## **RANGELINE PARK SUBDIVISION, EIGHTH ADDITION, RESUBDIVISION OF LOTS 1 & 2**

APPLICATION NUMBER 9 DATE June 2, 2005

APPLICANT Rangeline Park Subdivision, Eighth Addition, Resubdivision of Lots 1 & 2

# RANGELINE PARK SUBDIVISION, EIGHTH ADDITION, RESUBDIVISION OF LOT 1 AND LOT 2

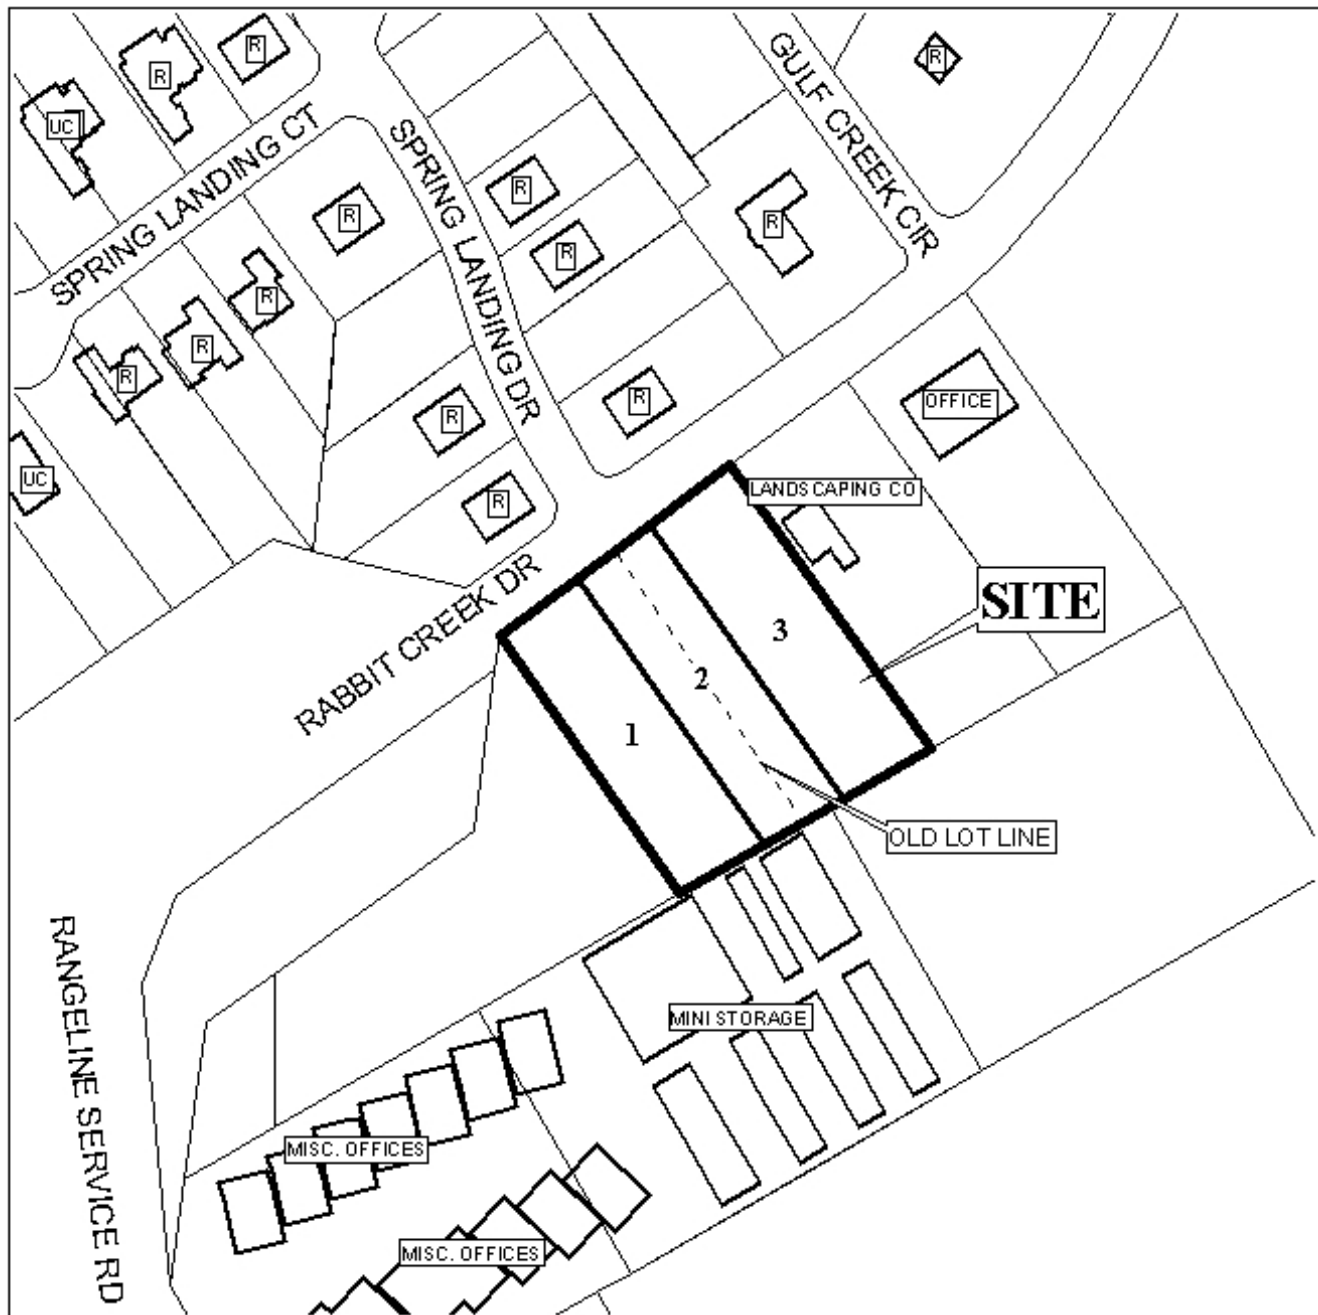
The site fronts Rabbit Creek Drive, which has a 60' right-of-way; this is illustrated as an 80' right-of-way on the final plat, which should be corrected. Also, the plat illustrates a 50' building setback, which is labeled as a 30' setback; however, only a 25' setback would be required, and this would be measured from the property line, not from the 10' easement. Thus the plat should illustrate a 25' minimum building setback from the property line.

The plat is recommended for Tentative Approval subject to the following conditions: 1) the placement of a note on the Final Plat stating that lots 1-3 are limited to one curb cut to be shared by all lots, with curb cut size, location and design to be approved by County Engineering; 2) the provision of a 10-foot landscape buffer along the portion of the site fronting Rabbit Creek Drive; 3) approval of all applicable federal, state and local agencies, regarding the wetlands and floodplain issues, prior to the issuance of any permits; 4) the placement of a note on the Final Plat stating that any lots that are developed commercially and adjoin residentially developed property must provide a buffer, in compliance with Section V.A.7 of the Subdivision

Regulations; 5) correction of the labeled right-of-way width for Rabbit Creek Drive; and 6) the depiction of the 25' minimum building setback line. It is also recommended that the application be advised that submission of a revised composite Rangeline Park subdivision application reflecting changes that have occurred would be appropriate prior to the submission of any future applications.
